Author: dttus Subject: Polygon Date: 12/28/2012 11:38:29 AM  
Plans are not complete, in that a full set of structural plans are not provided to facilitate a timely review and approval.

VOLUME 2 OF 2 - ZONING

# Summary of Comments on P:\Projects\1216-00\BIM\Revit\Families\TITLEBLOCKS\EXTELL Proposal\_atwalj.pdf

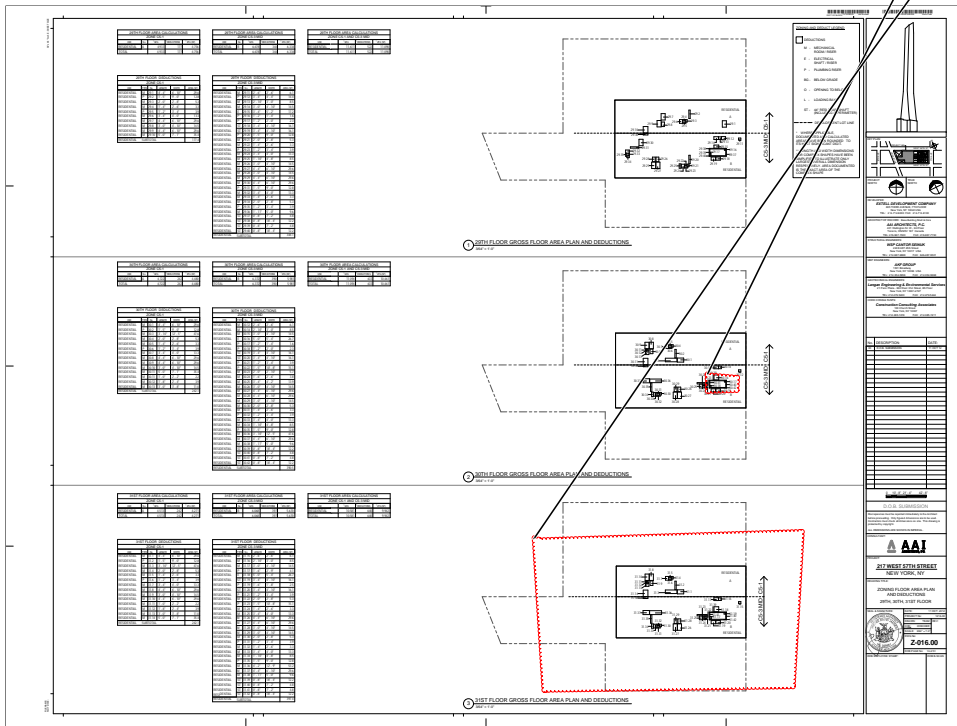
Please clarify deductions taken within stair inclosure. **TYP all floors**  
8" for the stair perimeter, not sure what the additional 60+ sq. ft. is for per floor. ARCH/MH dwgs does not indicate any shaft enclosures within stair.

Mech. plan was not provided for this floor. 31st FL.

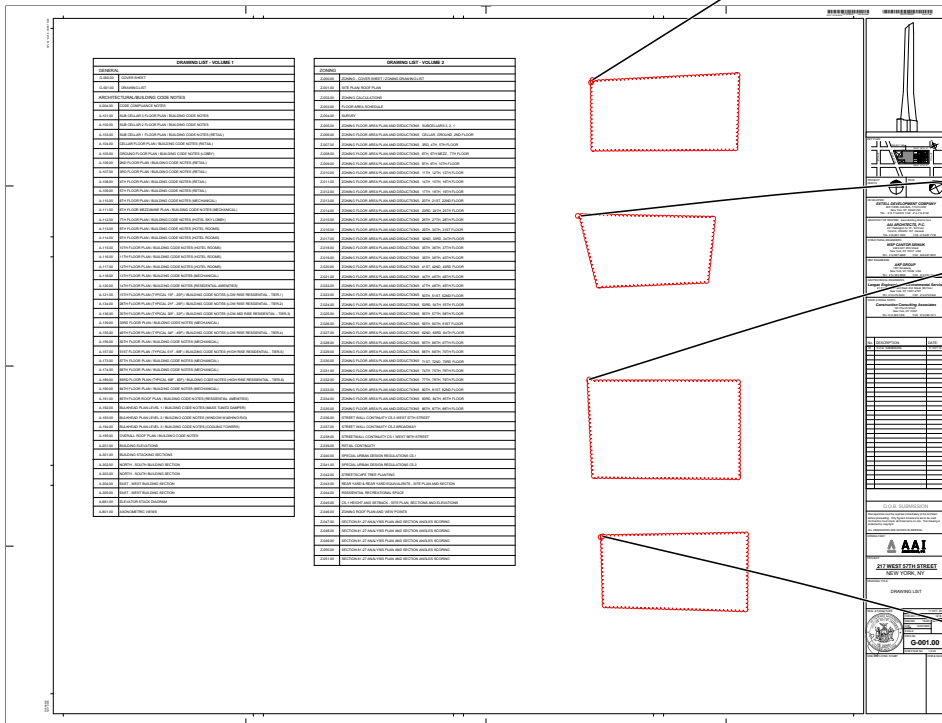
NYC ENERGY CODE 2011  
BC 1301 Provide data sheet and state on plans, full compliance with NYC energy code.

List all progress inspections for energy code compliance on drawing.

Supporting documentation: building wall sections fail to detail insulation as continuous and/or cavity insulation to match the location and R value in the energy analysis.

Supporting documentation: door, window and skylight schedules fail to provide columns for u values for each exterior door, window and skylight type. If door, window and skylight types are drawn instead, with specifications included next to the respective drawing, u and SHGC values must appear with the other performance specifications for clarity and ease of contractor take-offs.

Supporting documentation: heating and cooling systems, including controls, are not provided such that they match the systems, equipment and performance criteria in the energy analysis.

Supporting documentation: plans fail to include reflected ceiling plans or lighting layouts on floor plans with fixture types and quantities, lamp wattages and quantities, space areas, sensors and controls to match those in the energy analysis for each room in the building.

Supporting Documentation: Building wall sections fail to label insulation at the roof/ceiling, wall and/or at the foundation, slab-on grade, basement or cellar with R values matching those in the Energy Analysis.

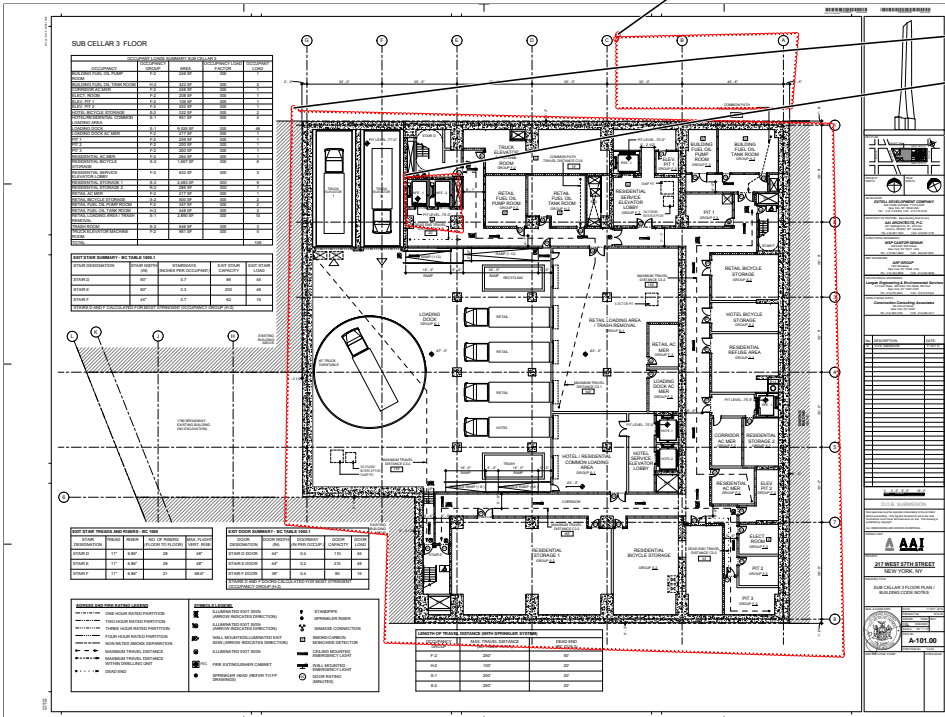
Indicate on drawings fire ratings for all proposed partitions /interior sections and details for verification purposes construction. Indicate construction materials and fire rating of construction elements of building to verify compliance with requirements of Table 601 class I-B structure.

BC 903.2.10 Trash compactor is required for building which contains more than 12 units.

- Indicate trash compactor size, dimensions, & location.
- indicate clearance around trash compactor
  - Indicate sprinkler locations in the trash compactor room.
  - indicate ventilation to fresh air at trash compactor room
  - provide floor drain at trash compactor room
  - Indicate a minimum, 3 hr fire rated enclosure (walls) at trash compactor room i, including 1 1/2hr FPSC rated door.
  - indicate construction details and materials at trash compactor room
  - Indicate sound transmission class (stc) ratings for all trash compactor walls and trash chute walls and disposal; room walls.

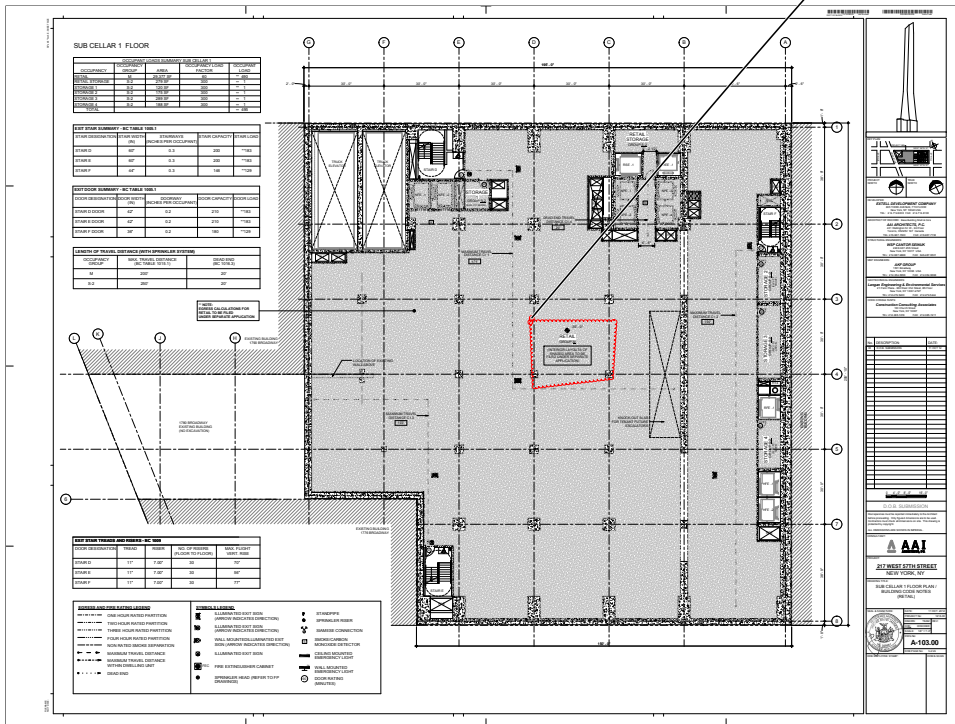
All nonresidential facilities to comply with BC 1109.

Required clearance around the water closet to comply with ICC/ANSI 2003 604.3

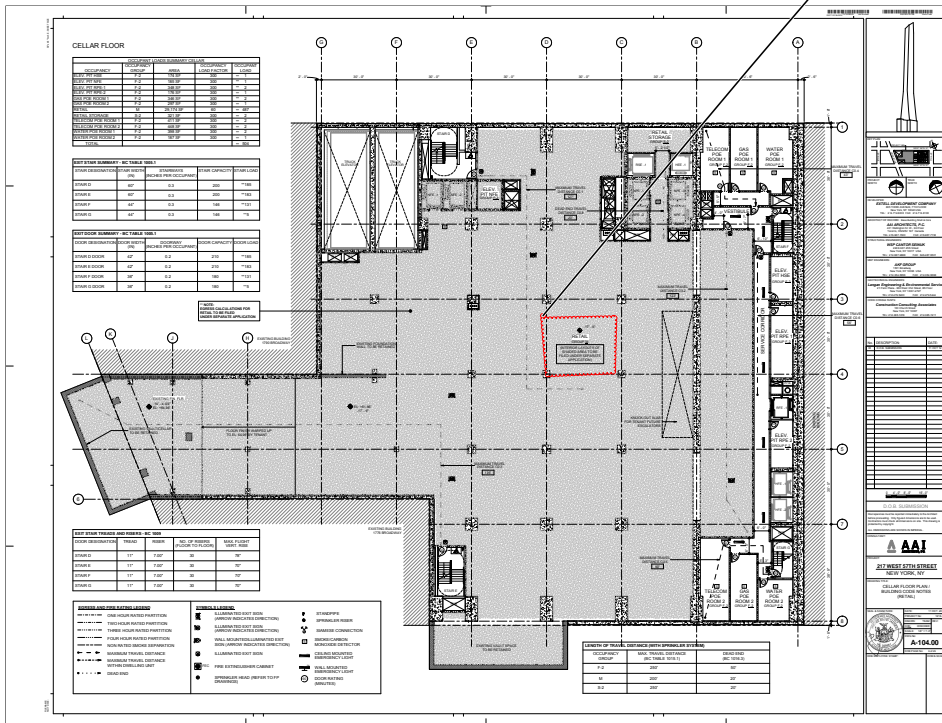
TABLE 403.1 Provide table for plumbing fixtures to comply with table. 403.1. Provide calculations within each space, etc. and show layout to verify compliance to BC 1101.2; ICC/ANSI A117.1-2003

All nonresidential facilities to comply with BC 1109.

Required clearance around the water closet ~~to~~ comply with ICC/ANSI 2003 604.3

Author: dtitus Subject: Polygon Date: 1/2/2013 12:52:48 PM  
Provide curb cut details with plans and sections. **filed**

Location of proposed curb cut is contrary to section BC 406.7.6 (3). This is not a corner lot and a minimum separation of 8'-0" is required from side lot line.

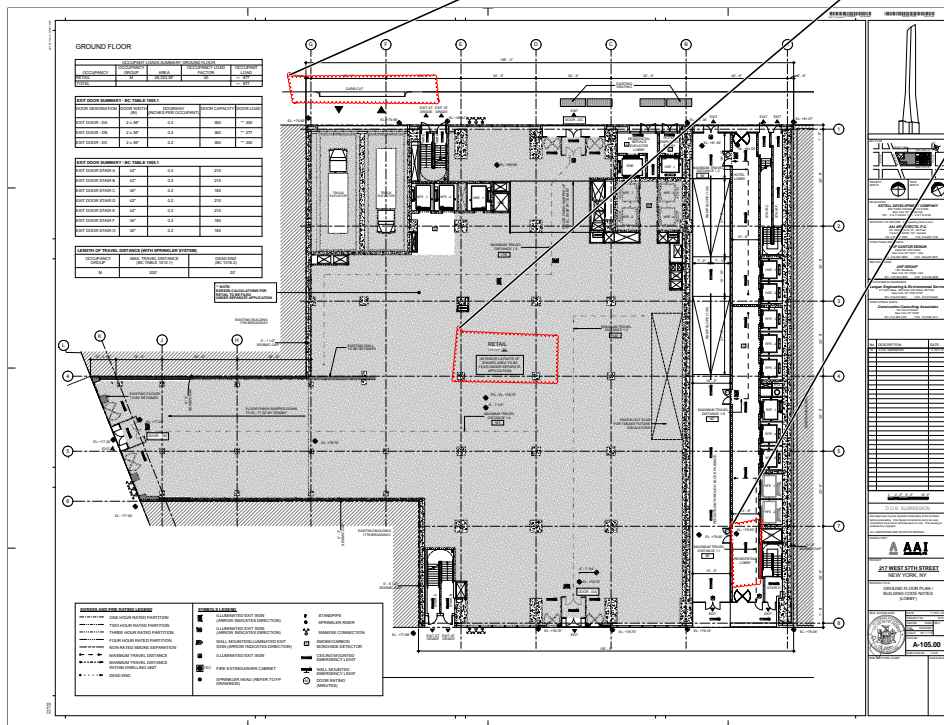
TABLE 403.1 Provide table for plumbing fixtures to comply with table. 403.1. Provide calculations within each space, etc. and show layout to verify compliance to BC 1101.2; ICC/ANSI A117.1-2003

All nonresidential facilities to comply with BC 1109.

Show all grab-bars including vertical

Required clearance around the water closet to comply with ICC/ANSI 2003 604.3

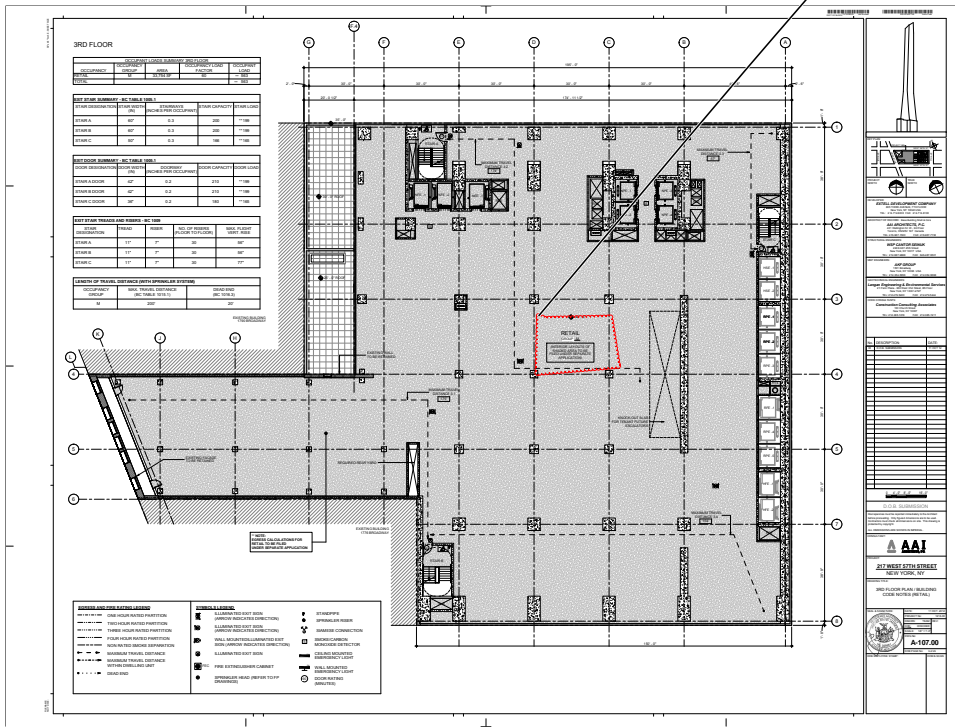
TABLE 403.1 Provide table for plumbing fixtures to comply with table 403.1. Provide calculations within each space, etc. and show layout to verify compliance to BC 1101.2; ICC/ANSI A117.1-2003

All nonresidential facilities to comply with BC 1109.

Show all grab-bars including vertical

Required clearance around the water closet to comply with ICC/ANSI 2003 604.3

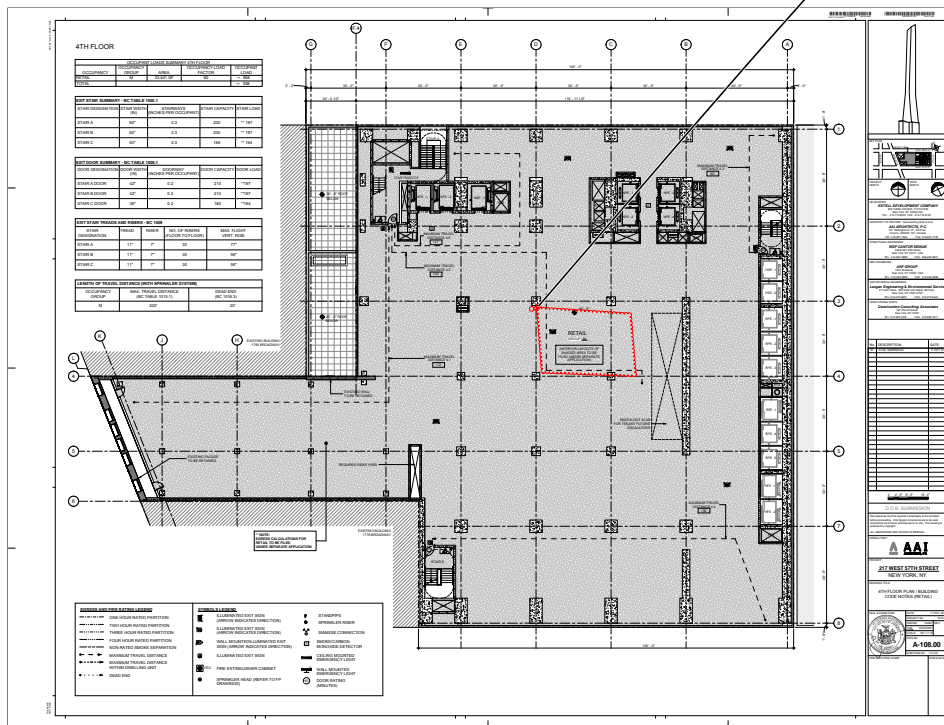
TABLE 403.1 Provide table for plumbing fixtures to comply with table 403.1. Provide calculations within each space, etc. and show layout to verify compliance to BC 1101.2; ICC/ANSI A117.1-2003

All nonresidential facilities to comply with BC 1109.

Show all grab-bars including vertical

Required clearance around the water closet to comply with ICC/ANSI 2003 604.3

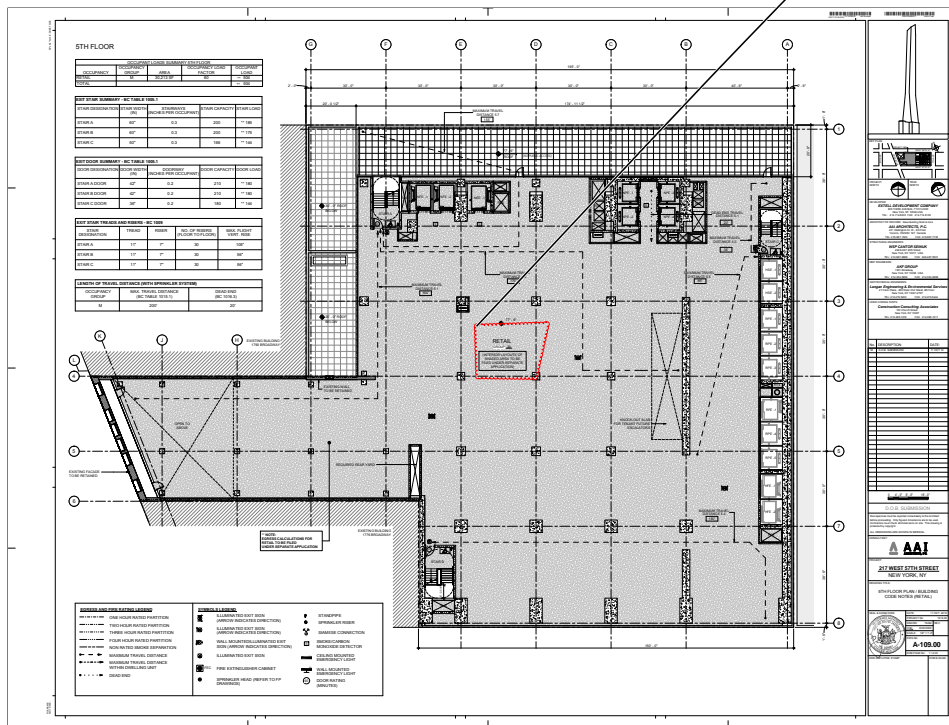
TABLE 403.1 Provide table for plumbing fixtures to comply with table. 403.1. Provide calculations within each space, etc. and show layout to verify compliance to BC 1101.2; ICC/ANSI A117.1-2003

All nonresidential facilities to comply with BC 1109.

Show all grab-bars including vertical

Required clearance around the water closet to comply with ICC/ANSI 2003 604.3

Provide exit lighting and directional signs (lighting) & (egress) as per BC 1006, BC 1011, BC 1026 (both EG and Construction plans)

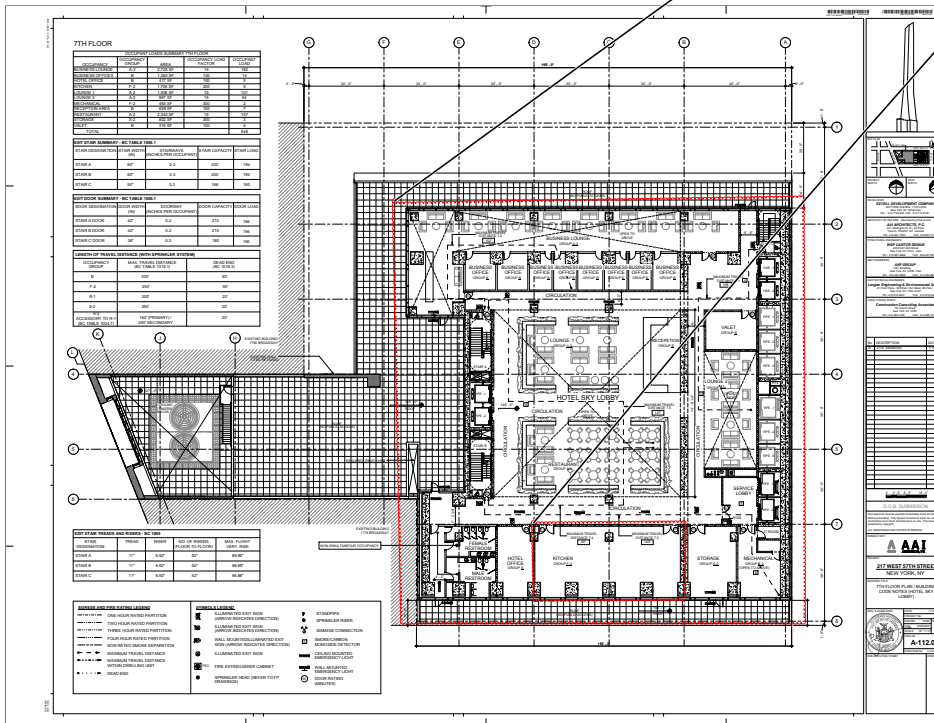
**BC 903.2.12.2 Commercial cooking operations.** An automatic sprinkler system shall not be installed in a commercial kitchen exhaust hood and duct system. Fire extinguishing systems shall be installed in commercial cooking systems in accordance with Section 904.11.

**BC 904.2.1 Hood system suppression.** Each required commercial kitchen exhaust hood and duct system required by the *New York City Fire Code* or the *New York City Mechanical Code* to have a Type I hood shall be protected with an approved automatic fire-extinguishing system installed in accordance with this code.

Kitchen shall also comply with MC 506, 507, and 508; PC 802.1.7 and 1003.3.1. Please verify on MH/PL plans.

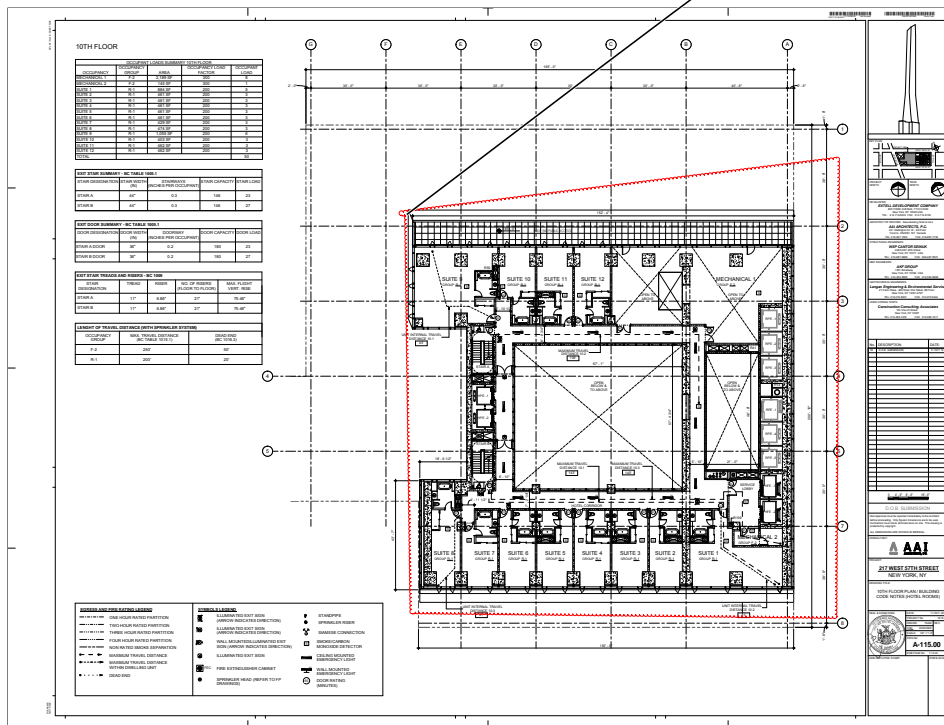
- Provide note describing stairway door operation and stairway communications system as per BC 403.12 04-16-13
- Provide note describing smoke proof exit enclosures for compliance with BC 403.13. 04-16-13
- Provide note describing impact-resistant stairs enclosures as per BC 403.15 04-16-13
- Indicate photo luminescent exit path markings as per BC 403.16. 04-16-13
- Provide exit lighting and directional signs (lighting) & (egress) as per BC 1006, BC 1011, BC 1026 (both EG and Construction plans) 04-16-13

- Group R-1 occupancies shall be provided with accessible features in accordance with Sections 1107.6.1.1 through 1107.6.1.3.
- Show all grab-bars including vertical as per P102.8.3.1, (TYP)
- Provide note within each accessible unit or sleeping unit shall comply with the 2008 code and Chapter 1 through Chapter 10 of ICC A117.1. (TYP) 04-16-13

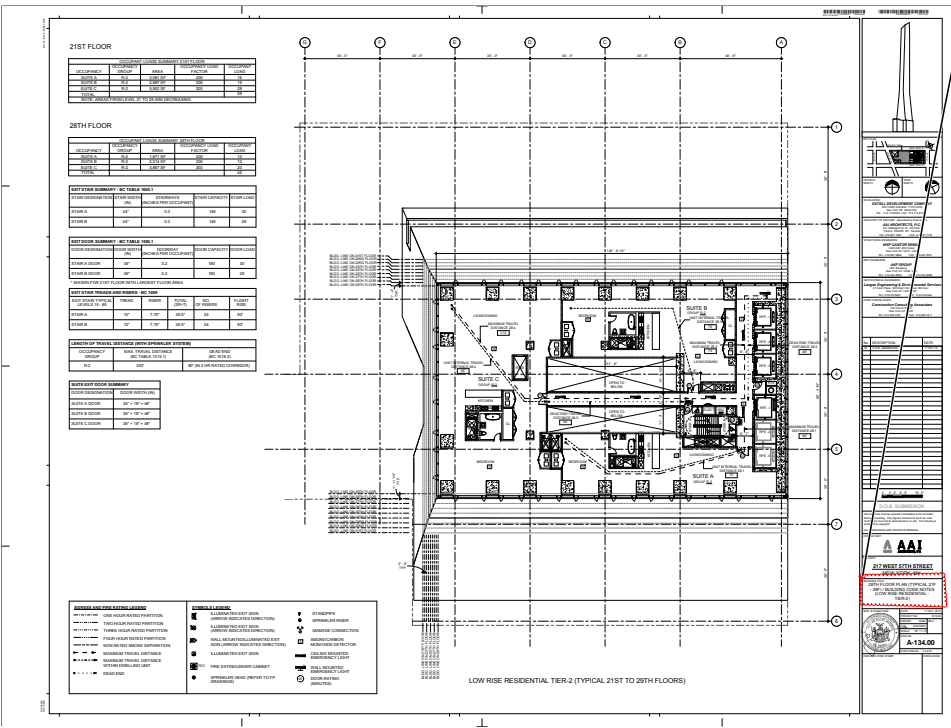
Author: dtitus Subject: Polygon Date: 1/7/2013 9:31:18 AM  
The common path of egress travel shall not exceed 125 feet as per BC 1013.3. The maximum length of exit access travel, measured from the most remote point within a story/space to the entrance to an exit along the natural and unobstructed path of egress travel, shall not exceed the distances given in BC Table 1015.1.

Author: dtitus Subject: Polygon Date: 1/7/2013 9:30:14 AM  
BC 908.7.1.2 Provide notes to indicate compliance for carbon monoxide detectors.  
Indicate location of smoke/ carbon monoxide detectors. (TYP.)

Author: dtitus Subject: Polygon Date: 1/4/2013 10:06:27 AM  
Provide refuse chute details: [2 hr fr walls & roof] and compliance with BC 1213.3 and BC 707.13  
Refuse storage room to comply with BC 1213.1  
Provide proper enclosure and details  
Provide UL # for system or fire hopper doors  
Compliance with BC 1101.2;

Author: dtitus Subject: Polygon Date: 1/4/2013 10:41:39 AM  
Provide note describing stairway door operation and stairway communications system as per BC 403.12  
Provide note describing smoke proof exit enclosures for compliance with BC 403.13.  
Provide note describing impact-resistant stairs enclosures as per BC 403.15  
Provide exit lighting and directional signs (lighting) & (egress) as per BC 1006, BC 1011, BC 1026 (both EG and Construction plans)

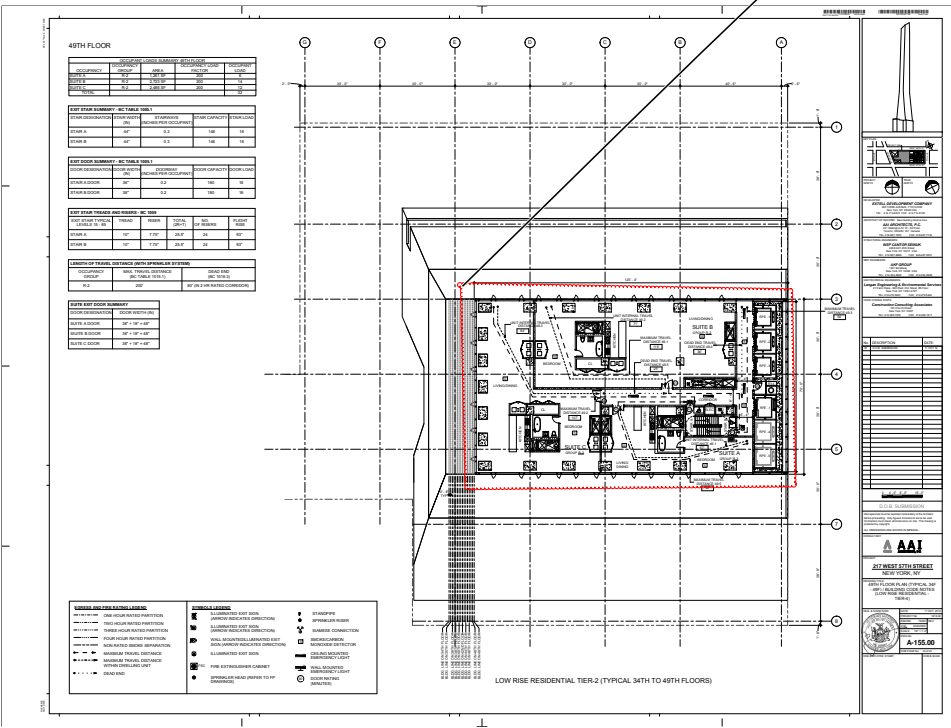
BC 1101.1, 1101.2, and  
ICC/ANSI A117.1-2003 Verify compliance with accessibility as per BC 1101  
Primary access- 1105  
Doors & maneuvering clearances-1107.2.1  
Residential bathrooms – 1107/ Appendix P  
Residential kitchens – 1107.  
Show all grab-bars including vertical as per P102.8.3.1,  
Walk-in closets  
Access to W/D within units  
**TYP. all R-2 floors**

Provide fire protection of openings in exterior walls (BC 704.8, BC 705.8, BC 715.4).
